Subject: AP1000 COL Standard Technical Report Submittal of APP-GW-GLN-019, Revision 2 (TR 103)

The changes within this Technical Report are a compilation of approved design changes to AP1000 Fluid Systems that have not previously been submitted under individual header. This document is sectioned to identify Fluid System changes that have been approved by the Westinghouse Change Control Board, that have not been submitted in previous Technical Reports, and that have had a direct impact on the Design Control Document (DCD). These are predominantly minor changes in system designs that are due to the progression of the detailed design. Each change will be individually identified within this document. The description of these changes can be found within Section II of this document. Additionally, not all of the changes described within this document have been incorporated into Rev. 16 of the AP1000 Design Control Document. The changes to R16 are detailed on pages 144 to 149.

Title: Fluid System Changes

Figure 5.4-7
 Normal Residual Heat Removal System
 Piping and Instrument Diagram

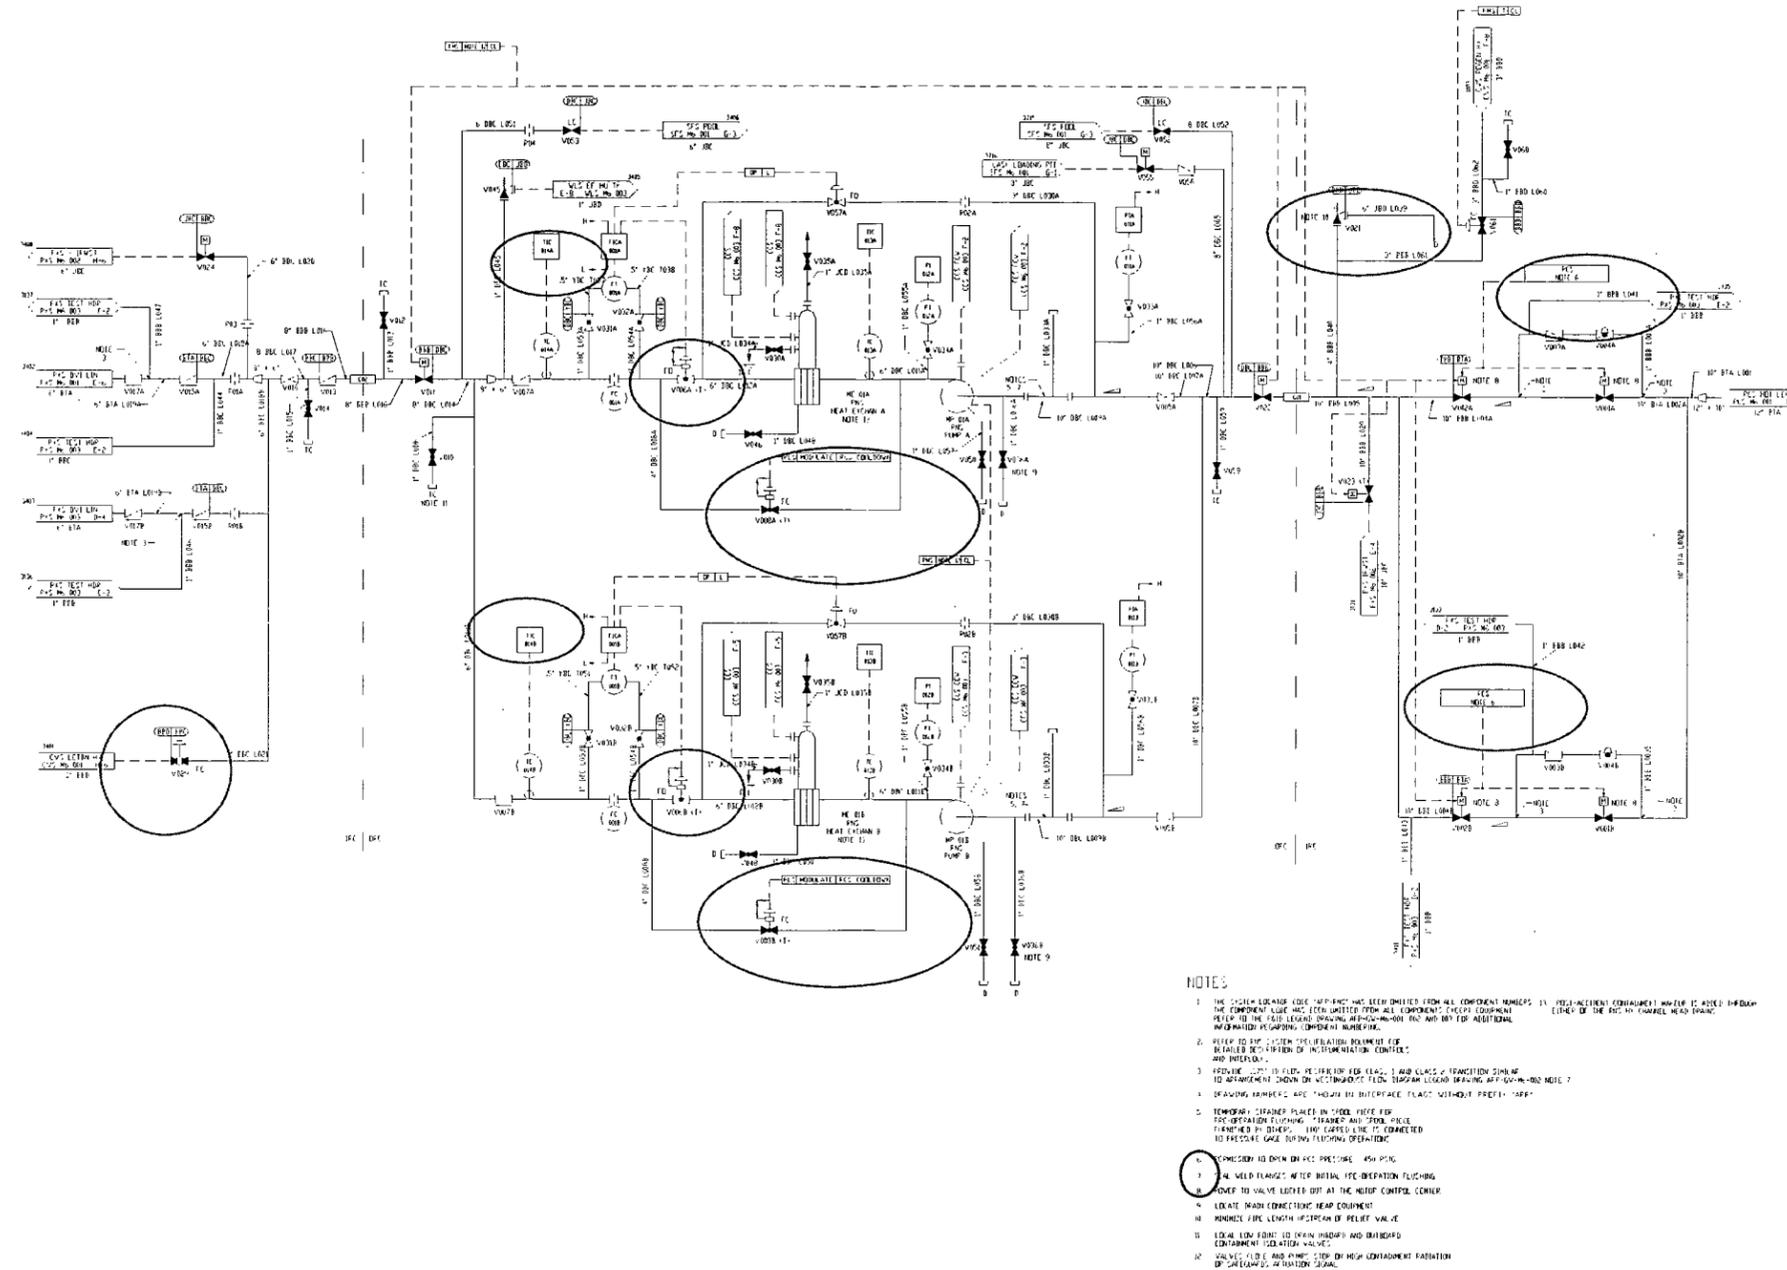
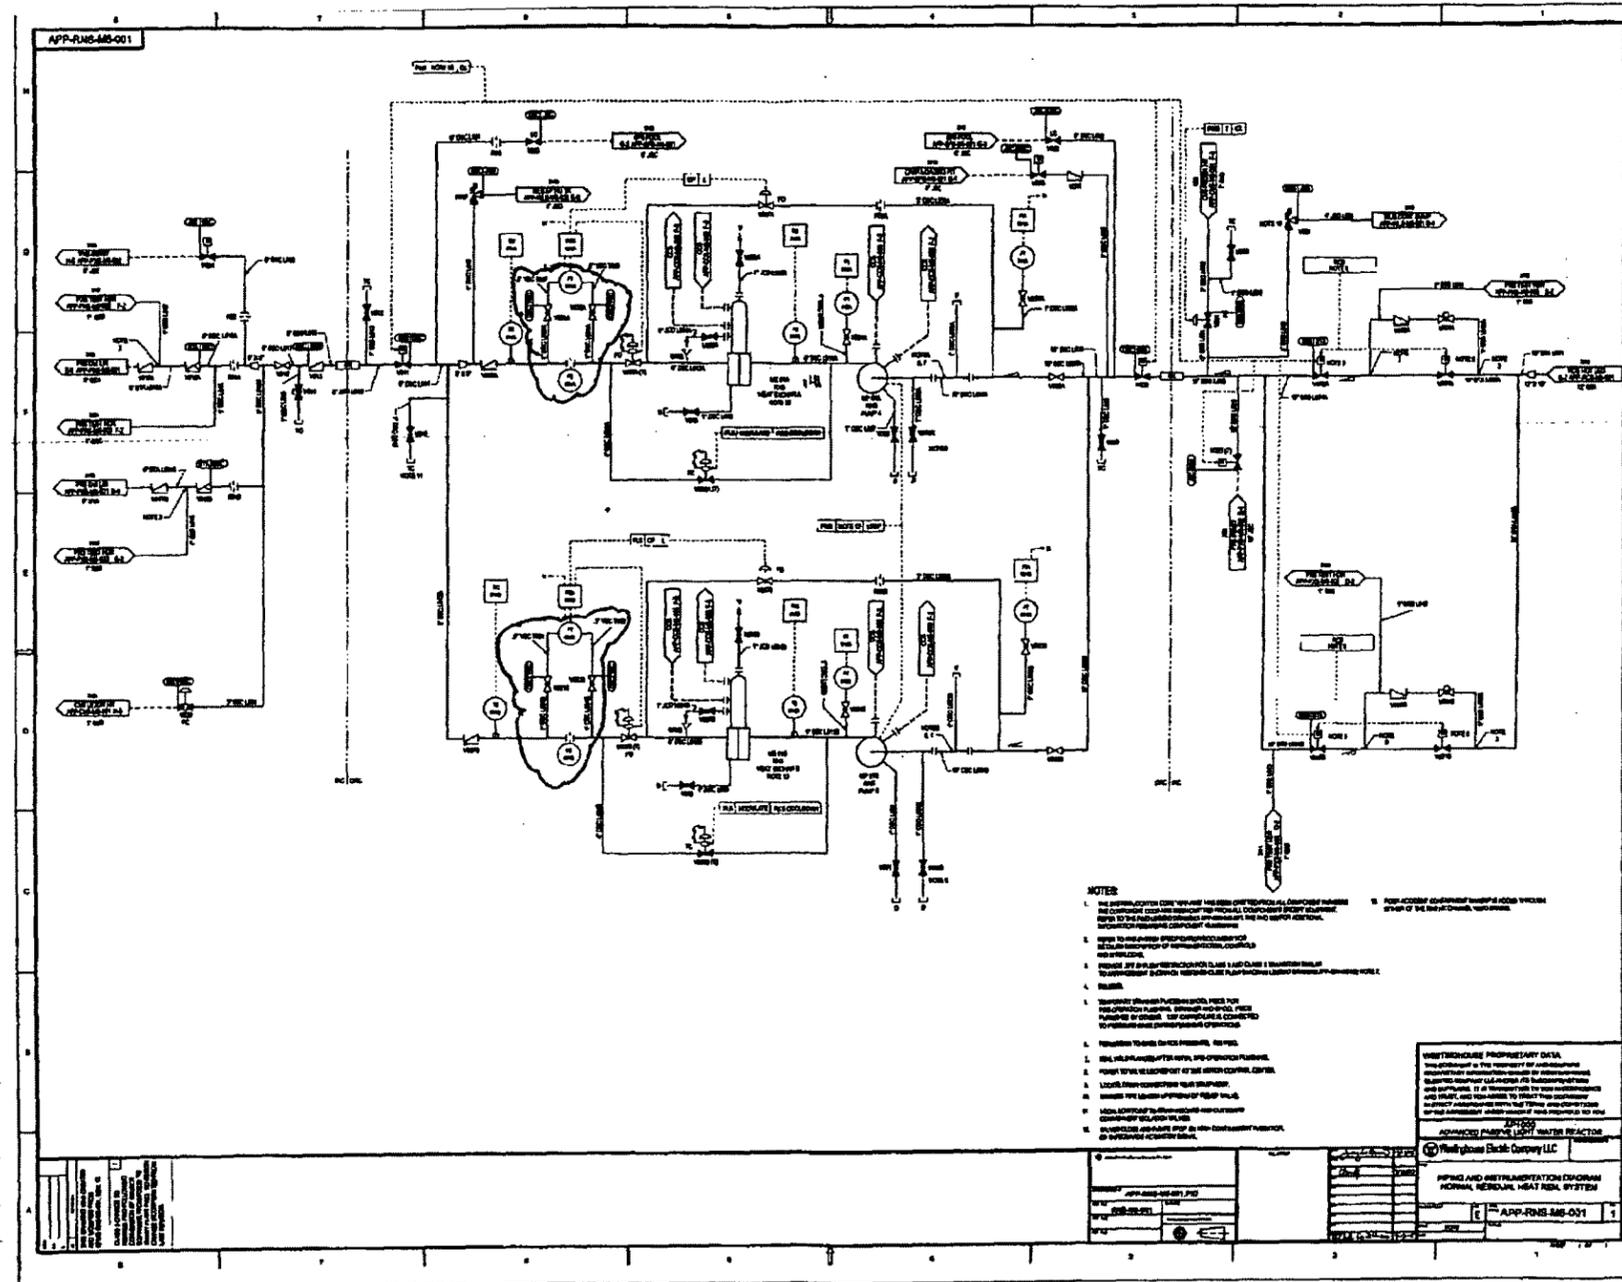
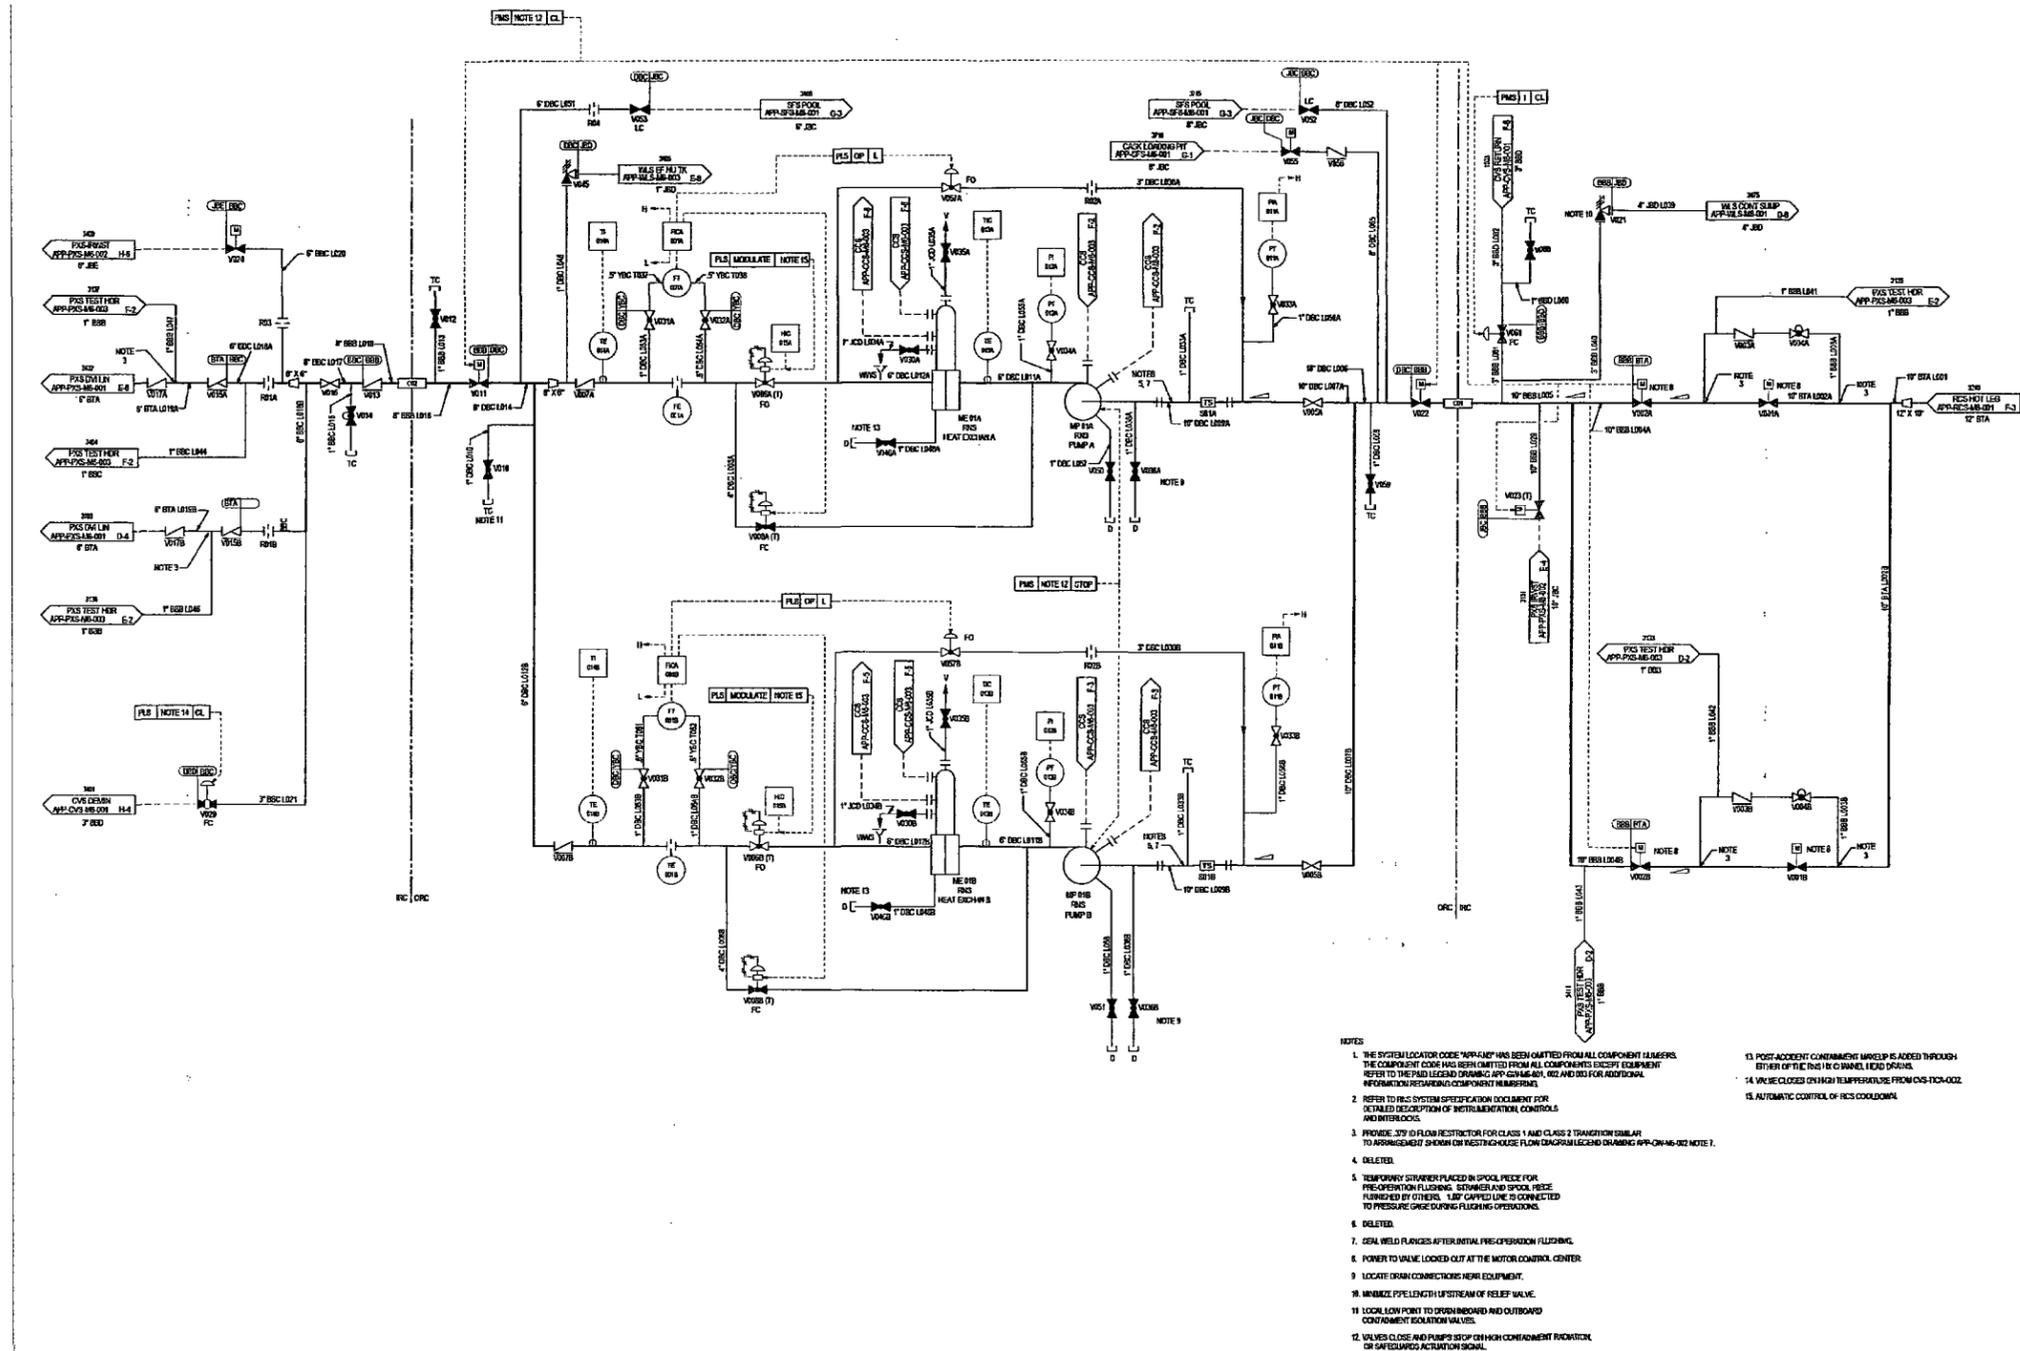
The RNS relief valve size shown in Figure 5.4-7 of the DCD R15 has been modified from a 4" inlet and a 6" outlet to a 3" inlet and a 4" outlet. The RNS relief valve is sized for two conditions. The relief valve must be capable of mitigating primary overpressure events at low temperature conditions due to a heat injection, and it must also be able to mitigate a mass injection transient where the mismatch flow rate is no higher than 177 gpm. In order to use a 4" x 6" valve an orifice would be employed which has a relieving capacity that is more than twice the necessary capacity. This is not recommended due to valve instability caused by the valve being
